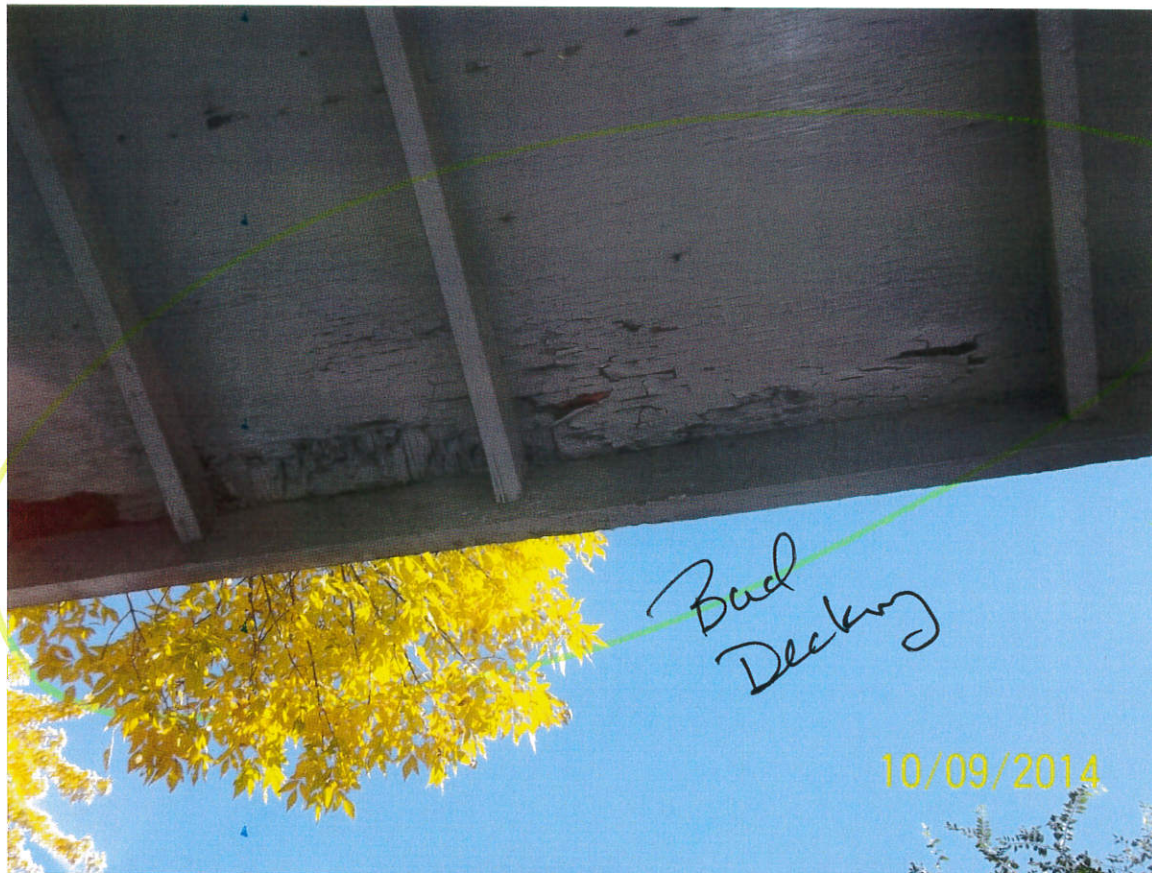
Spliced
OUT of post.
Very Bad
Connection
&
Unsafe.

Splice
Top of
Post.
+ Improper
Connections.

*Improper
Connections*

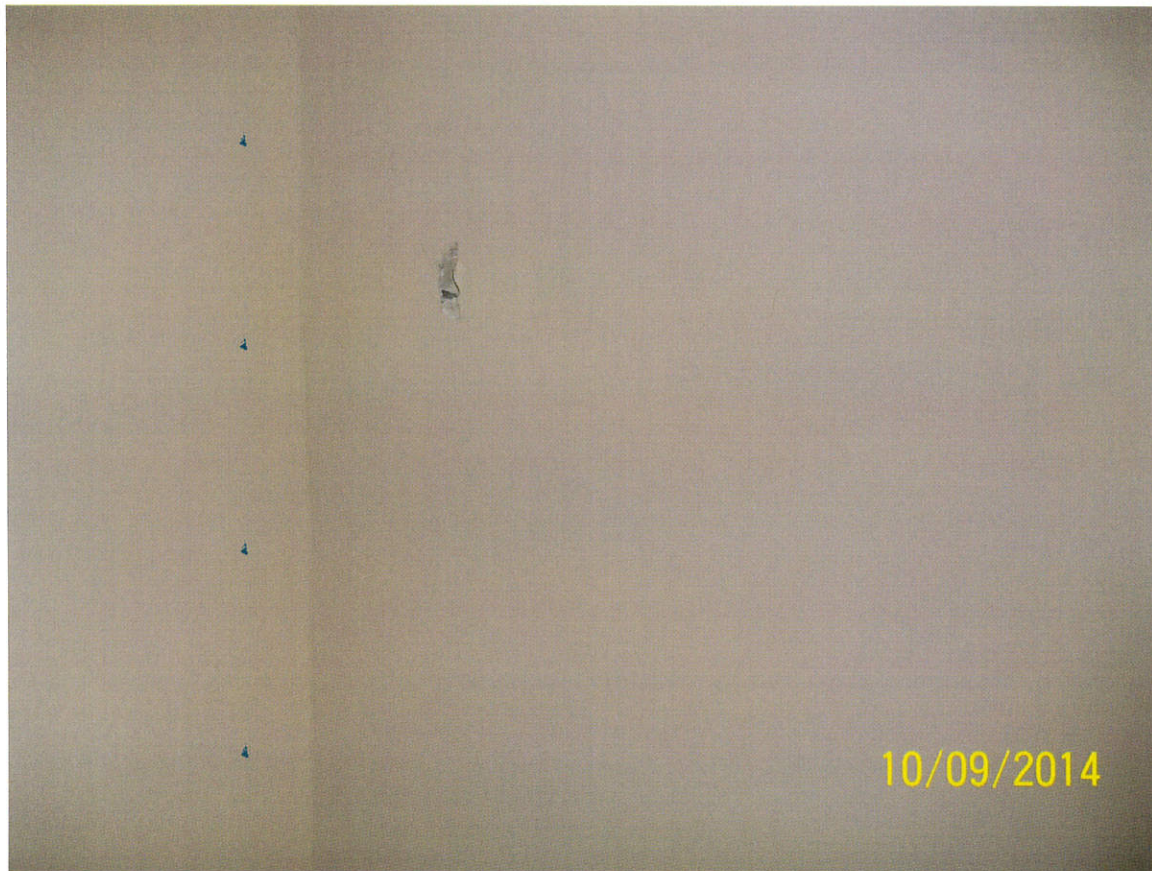
Doubt if
Just
for Proper
Construction.

Improper
Connectors.

Improper
Connections
